**AMENDMENTS TO THE DRAWINGS**

Application No.: 10/679,421  
(80408-0008)

Docket No.: TOC-0008

FIG. 2A

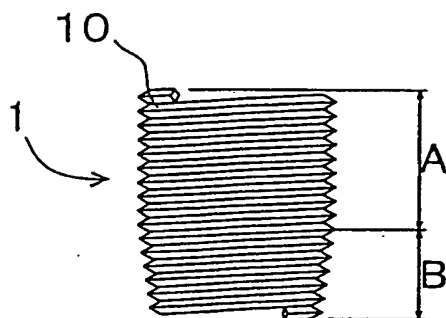
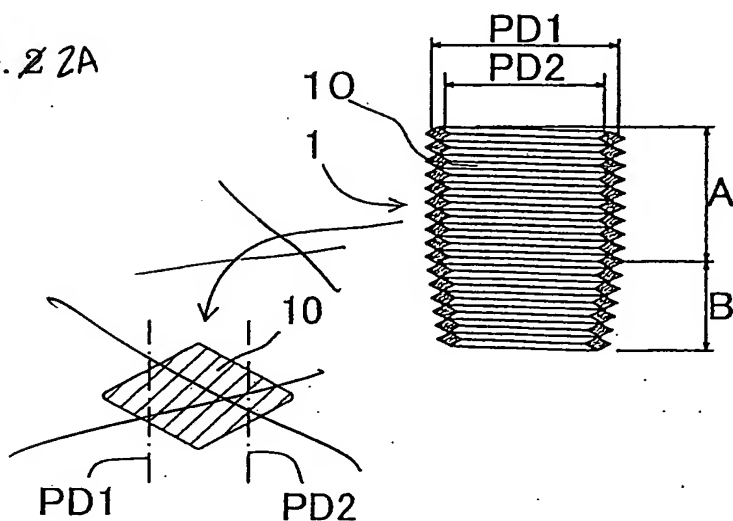
Sheet 1: Please amend Figure 2 by changing the figure designation to Figure 2A and removing the cross sectional view of element 10 as shown.

Sheet 1: Please add new Figure 2B that illustrates the cross sectional view of element 10 previously included in Figure 2 as shown.

Fig. 2 of the drawings was objected to for improperly showing a cross sectional view of element 10. As discussed above, Applicant has newly designated Fig. 2 as Fig. 2A and removed the cross-sectional view of element 10. Moreover, Applicant has added Fig. 2B, which includes the cross-sectional view of element 10 previously shown in Fig. 2. Accordingly, Applicant respectfully requests that the objections to the drawings be withdrawn.

In the drawings, Fig. 2 has been amended to remove the section view of element 10, and Fig. 2 has been newly designated as Fig. 2A. Fig. 2B has been added to include the sectional view previously included in Fig. 2. No new matter has been added.
